PG&E Letter DCL-11-059

Diablo Canyon Units 1 and 2  
Docket No. 50-275, OL-DPR-80  
Docket No. 50-323, OL-DPR-82  
License Amendment Request 11-04

Revision to Technical Specification (TS) 3.6.6, "Containment Spray and Cooling Systems," TS 3.7.5, "Auxiliary Feedwater (AFW) System," TS 3.8.1, "AC Sources - Operating," TS 3.8.9, "Distribution Systems - Operating," and TS Example 1.3-3

Figure 1 – Auxiliary Feedwater Simplified System Diagram  
 AUXILIARY FEEDWATER SIMPLIFIED SYSTEM DIAGRAM

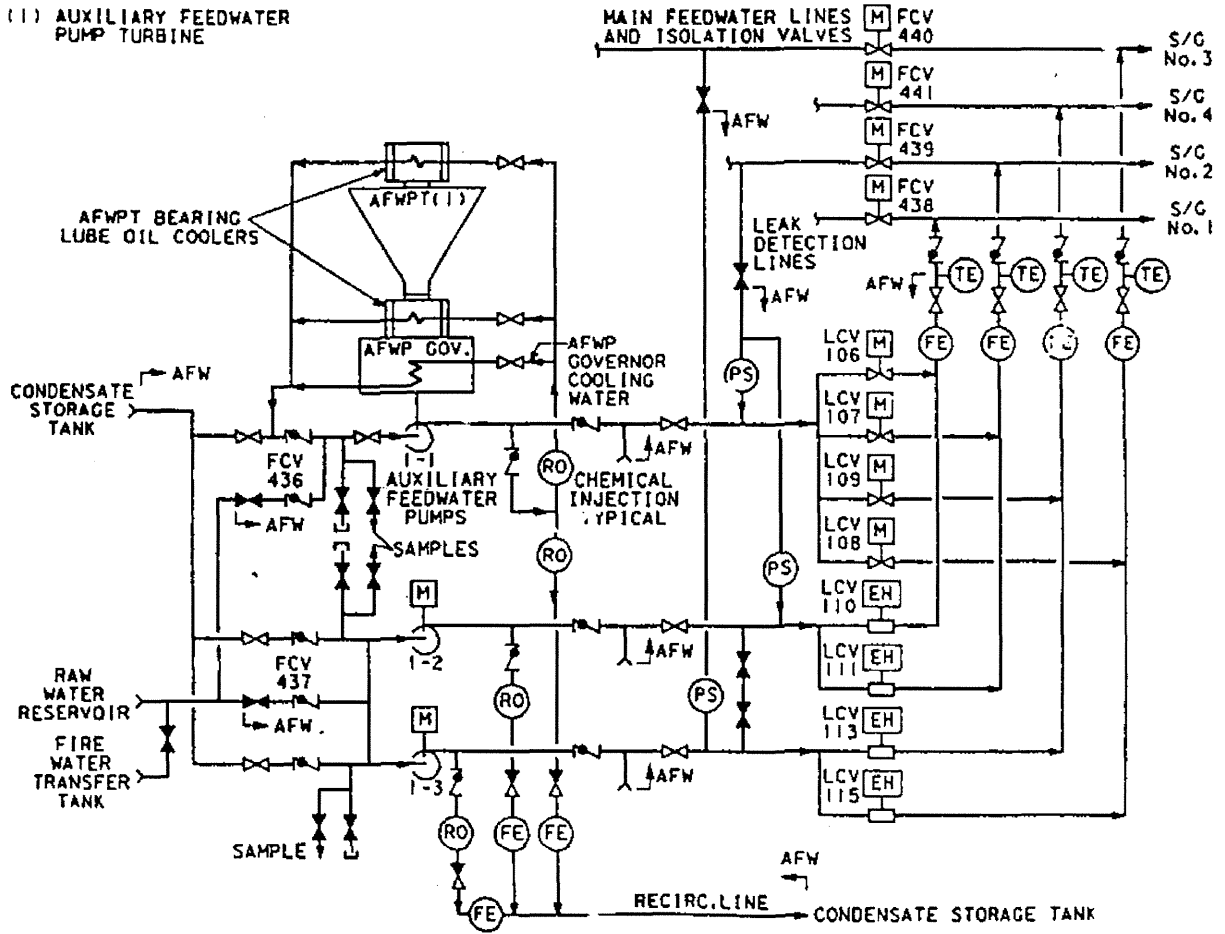
The purpose of this change is to address a design feature of the AFW system that has not been previously reviewed by the NRC. This change would provide specific actions to be taken when automatic control of one or more of the MDAFW pump level control valves is inoperable, but manual operation from the control room remains available.

- A new Condition B is added to state: "One or more motor driven AFW trains with automatic control of one motor driven AFW level control valve per train inoperable."
- New Required Action B.1 is added to state, "Place affected AFW level control valve(s) in manual control with valve demand full open." This action is modified by a note: "No change in valve demand is required if AFW is being relied upon for SG level control." The purpose of this note is to preclude introducing transients when the AFW system is actively being relied upon.
- New Required Action B.2 is added with an OR connector to state: "Declare the associated AFW train inoperable."
- The existing Condition B becomes Condition C.

This change will address inoperable automatic control of MDAFW pump LCVs, including a failure mechanism of Eagle 21 where failure of a Loop Calculation Processor (LCP) card from a rack lock-up affects automatic SG LCV control on both MDAFW pump trains. The intended design response to an Eagle 21 LCP failure is to lock-up the control output in a "fail-as-is" status to minimize plant transients as a result of a single failure. An Eagle 21 rack lock-up affects automatic control of one LCV on each of the MDAFW pump trains.

The MDAFW train LCVs are designed to have manual operator control override capability by manual intervention at the manual/auto controller in the control room. When the LCV controller is placed in manual, automatic pump runout protection is not provided by that LCV. The other AFW LCV in automatic will continue to provide runout protection for that MDAFW train, precluding pump runout. The valve demand signal must be manually set so LCVs will appropriately open and provide adequate flow upon AFW actuation.

Distribution Systems - Operating

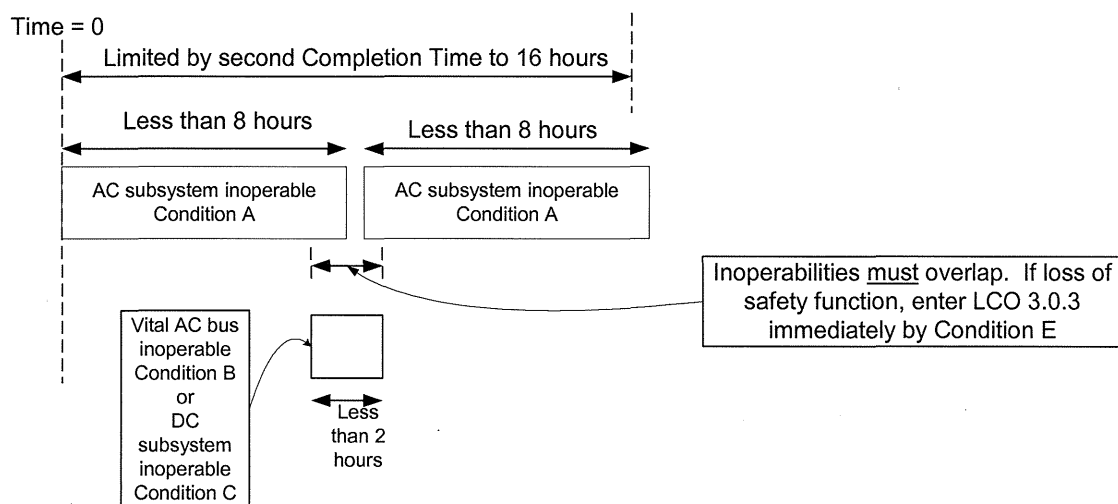
Specification 3.8.9, Distribution Systems - Operating, has an 8-hour Completion Time for one AC electrical power distribution subsystem inoperable (Condition A), and a 2-hour Completion Time for one 120 VAC vital bus subsystem inoperable (Condition B) or one DC electrical power distribution subsystem (Condition C) inoperable. Conditions A, B, and C have a second Completion Time of 16 hours from discovery of failure to meet the LCO. Condition E applies if two required Class 1E AC, DC, or 120 VAC vital buses are inoperable with an inoperable distribution subsystems that result in a loss of safety function, and LCO 3.0.3 must be entered immediately. See Example 2.

The second Completion Time is not needed. First, it is unusual for an AC electrical power subsystem or AC vital bus to be inoperable without causing a reactor trip. Secondly, Completion Times are very short (8 and 2 hours) providing little time to restore systems such that the Conditions overlap and multiple inoperabilities occur. Lastly, should any overlapping inoperabilities that result in a loss of safety function occur, a plant shutdown in accordance with LCO 3.0.3 is required.

Containment Spray and Cooling

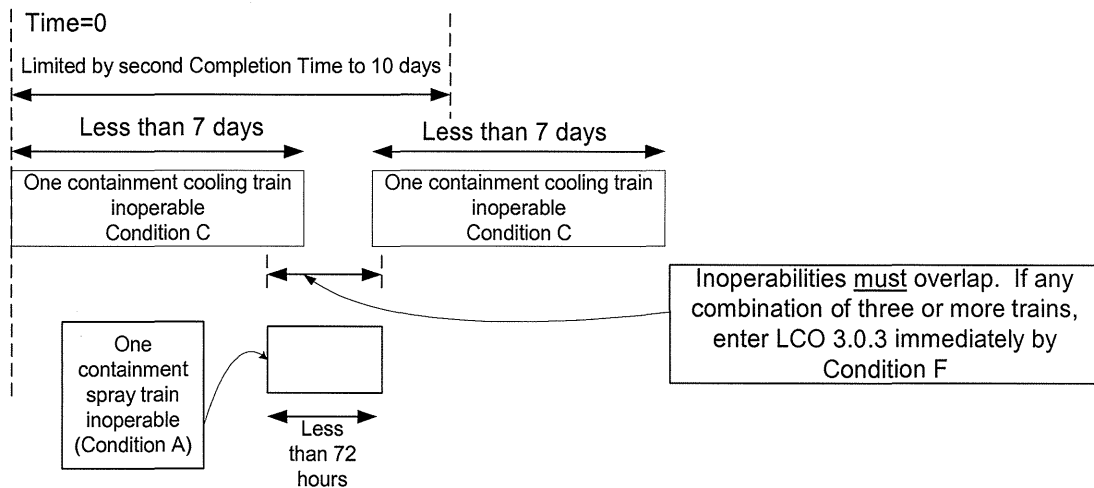
Specification 3.6.6, Containment Spray and Cooling Systems, has a 72-hour Completion Time for one containment spray train inoperable (Condition A) and a 7-day Completion Time for one required containment fan cooler unit (CFCU) system inoperable such that a minimum of two CFCUs remain OPERABLE (Condition C). Conditions A and C have a second Completion Time of 10 days from discovery of failure to meet the LCO. Condition A also has an additional second completion time of 14 days that applies for unplanned corrective maintenance or inspections. Condition F also applies if two containment spray trains are inoperable or with one containment spray train inoperable and two CFCU systems inoperable such that one or less CFCUs remain OPERABLE or one or less CFCUs OPERABLE (LCO 3.0.3 must be entered immediately. See Example 3 for an illustration of TS 3.6.6 (Example 3 is from TSTF-439, and uses “containment cooling train” instead of CFCU. This does not affect the analysis)

The second Completion Time is not needed. Any combination of two of the four trains can perform the safety function. Adverse combinations require entry into LCO 3.0.3. The second Completion Time restricts operation with only one train inoperable, but that is unnecessary because when one train is inoperable, there are still three operable trains and only two trains are needed to perform the safety function. Therefore, the second Completion Time is overly restrictive.

Auxiliary Feedwater System

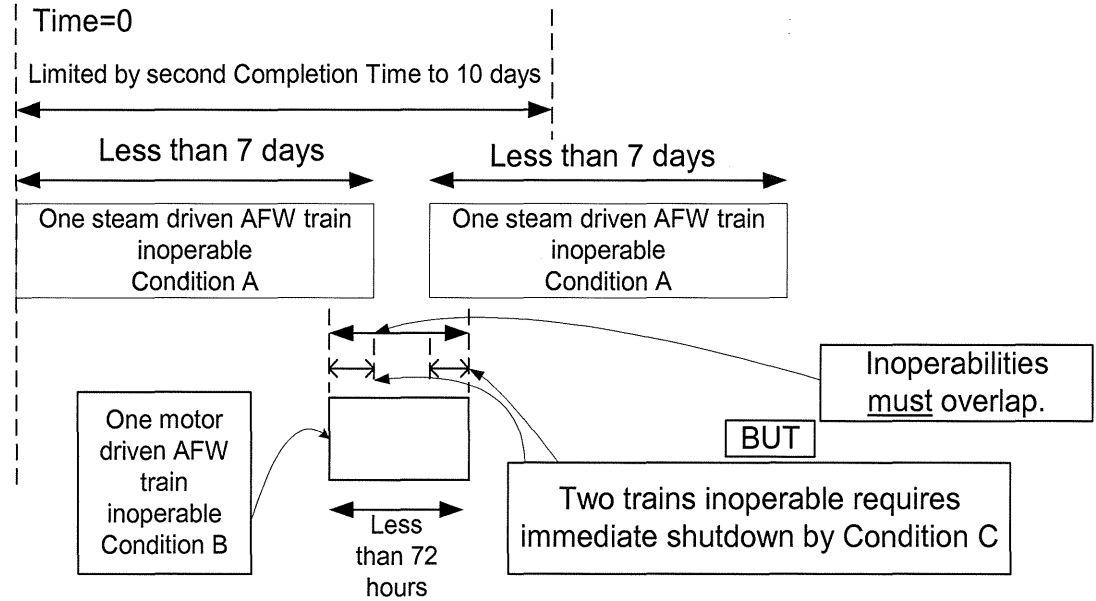
Specification 3.7.5, Auxiliary Feedwater System has a 7-day Completion Time for one steam supply to a turbine driven AFW pump inoperable (rendering the turbine driven AFW pump inoperable) (Condition A) and a 72-hour Completion Time for one AFW train inoperable in MODE 1, 2, or 3 for reasons other than Condition A (Condition B). Conditions A and B have a second Completion Time of 10 days from discovery of failure to meet the LCO. In order for the second Completion Time to be limiting, entry into and out of Conditions A and B must occur, which requires the turbine driven and motor driven AFW pumps to be concurrently inoperable. However, Condition C states that if Required Action and associated Completion Time for Condition A or B not met OR two AFW trains are inoperable in MODE 1, 2, or 3, the plant must be in MODE 3 in 6 hours and MODE 4 in 18 hours. See Example 4.
